**PLANNED UNIT DEVELOPMENT  
STAFF REPORT****Date: August 5, 2010****DEVELOPMENT NAME**

MYMS, Inc.

**LOCATION**2908 Springhill Avenue  
(Northeast corner of Springhill Avenue and Union Avenue)**CITY COUNCIL  
DISTRICT**

**CONTEMPLATED USE**Planned Unit Development Approval to modify an existing  
Planned Unit Development approval allowing shared  
access between two building sites.**TIME SCHEDULE  
FOR DEVELOPMENT**

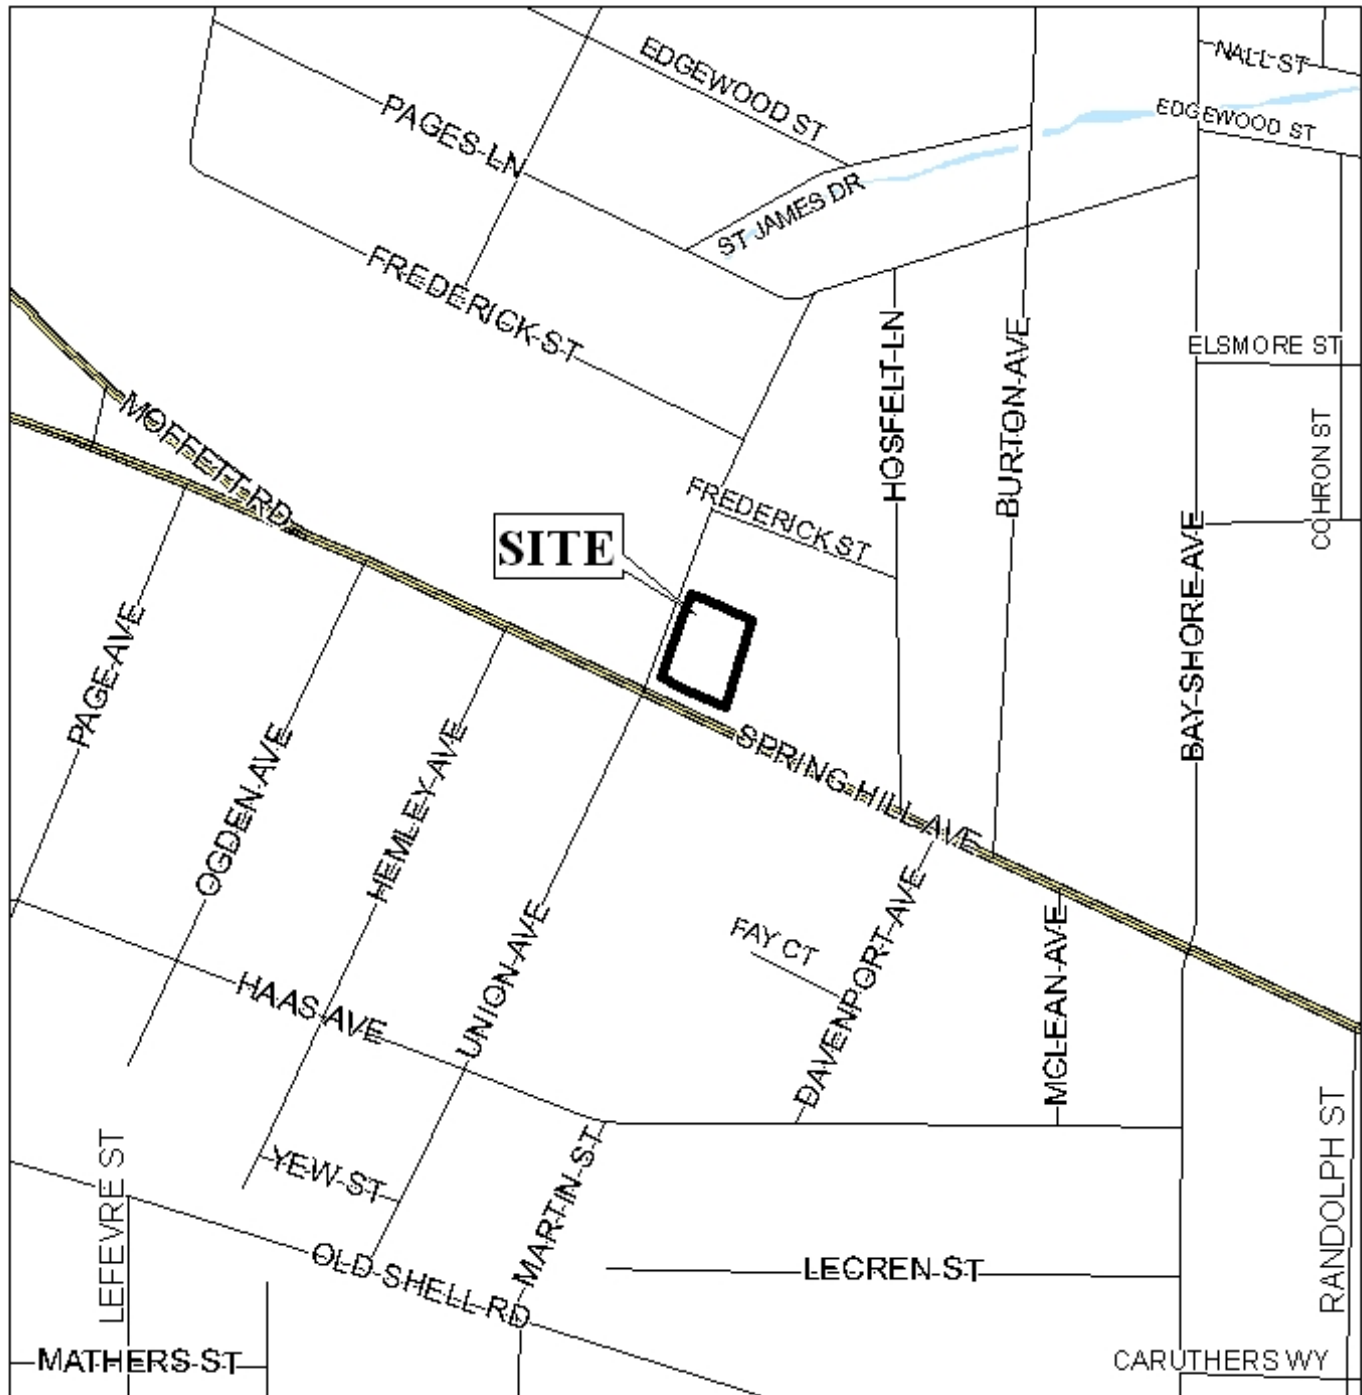
The site plan depicts the proposed one-way, 12-foot wide accessway along the western side of the building connecting the front and rear parking lots. Appropriate “one-way” and “do not enter” signage is also depicted. Directional arrows are not depicted, and appropriate directional arrows (a minimum of two) should be installed on the accessway. Additionally, a “stop” sign should be placed at the northern terminus of the accessway due to limited site distance because of the building. The site plan also depicts a 36-inch high handrail along the walkway along the west side of the building. This handrail would seem to be adequate to protect customers on the walkway.

The site plan depicts 6 (six) parking spaces at the front parking lot, however, one of the parking spaces (and the space’s bumper stop) encroaches into the accessway area. This parking space and bumper stop should be removed so as not to impede entry to the accessway. This would leave the site with a total of 13 parking spaces, which is adequate under the Zoning Ordinance.

Both the front and total landscaping on the site will be reduced by the addition of the proposed accessway, however, the areas will remain of adequate size to meet the requirements of the Zoning Ordinance.

- 1) revision of the site plan to remove the westernmost parking space and bumper stop to depict five parking spaces in the front parking lot facing Springhill Avenue;

- 2) revision of the site plan to depict at least two directional arrows on the accessway;
- 3) revision of the site plan to depict a “stop” sign at the northern terminus of the accessway;
